Re: Unser West

**RE: CONCEPTUAL DRAINAGE PLAN FOR UNSER WEST
(ATRISCO BUS. PARK, L-1-A, L-1-B, L-1-C)
ENGINEER'S SUBMITTAL DATED 12/01/00**

LETTER OF TRANSMITTAL

EXHIBIT
L-1-A, L-1-B & L-1-C
ATRISCO BUSINESS PARK
WITHIN THE
TOWN OF ATRISCO GRANT
PROJECTED SECTION 22
TOWNSHIP 10 NORTH, RANGE 2 EAST, NMMP
CITY OF ALBUQUERQUE
BERNALILLO COUNTY, NEW MEXICO
AUGUST, 2000

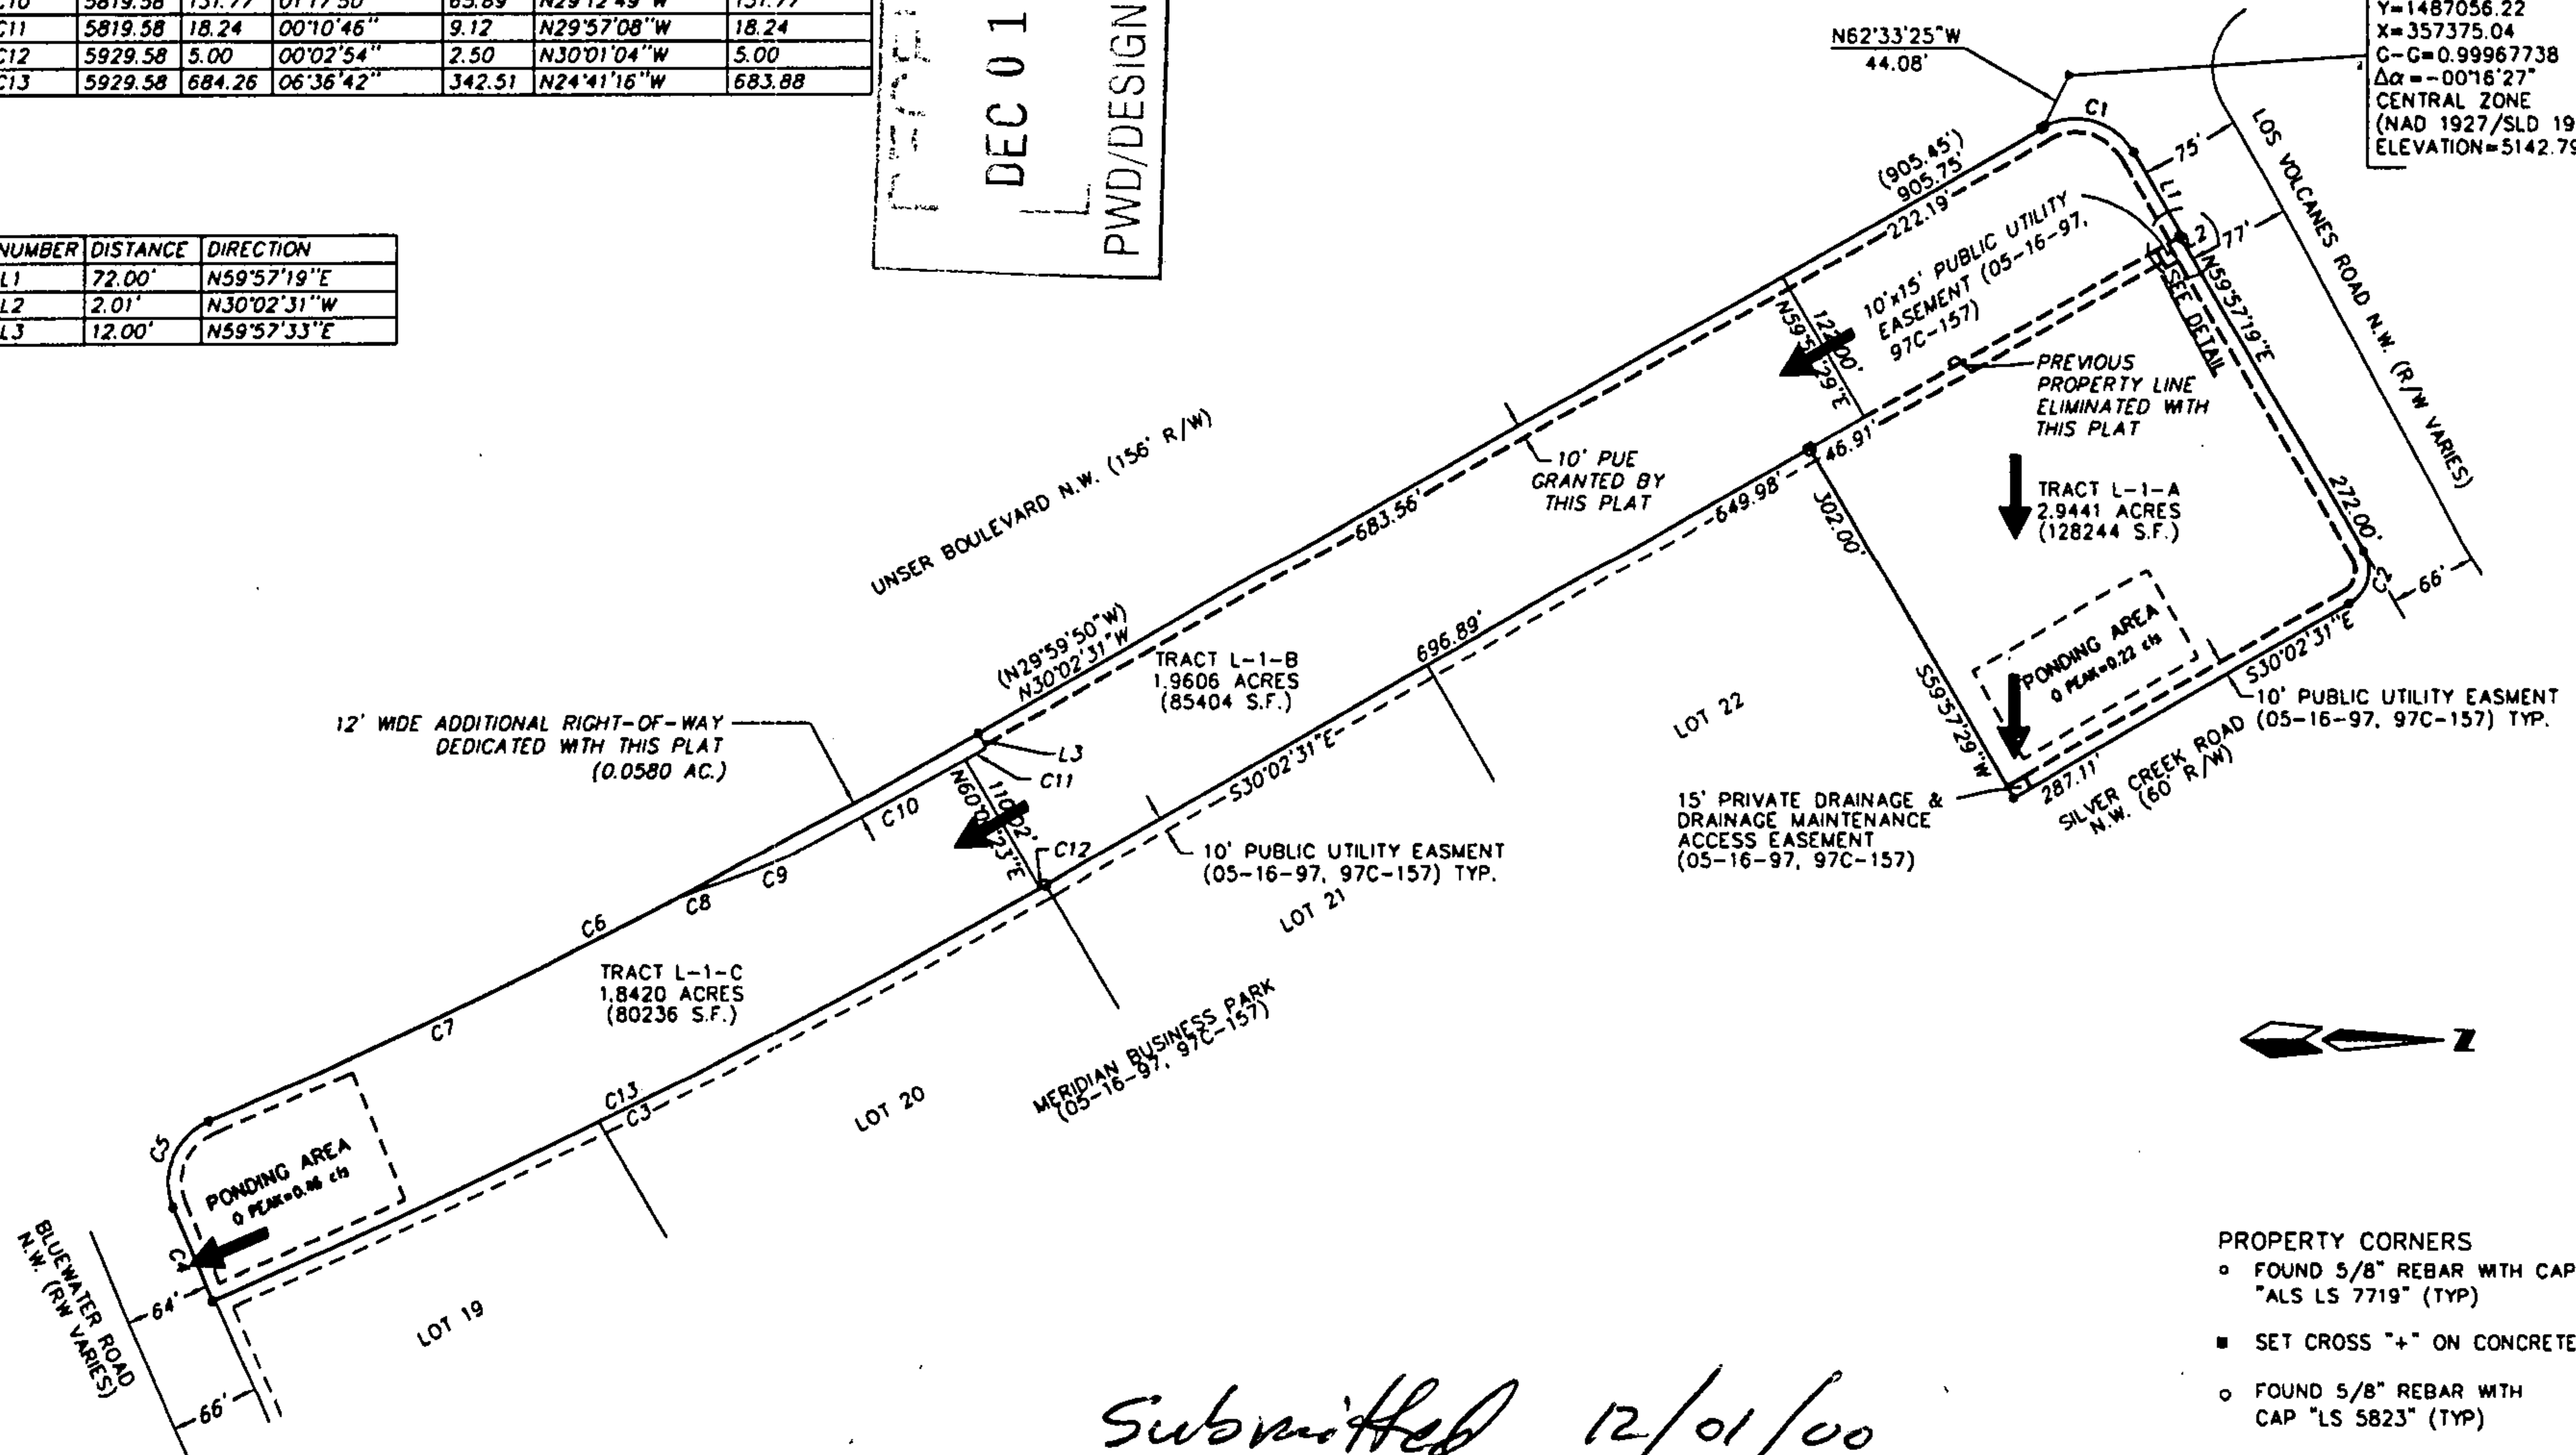
At this time, there is not a final building layout so providing a realistic Master Drainage Plan is not feasible. However, attached is a layout of the property showing peak discharges and ponding locations.

The referenced Conceptual Drainage Plan is approved for Preliminary Plat. Final grading and drainage plans will be reviewed as part of site plan for building permits.
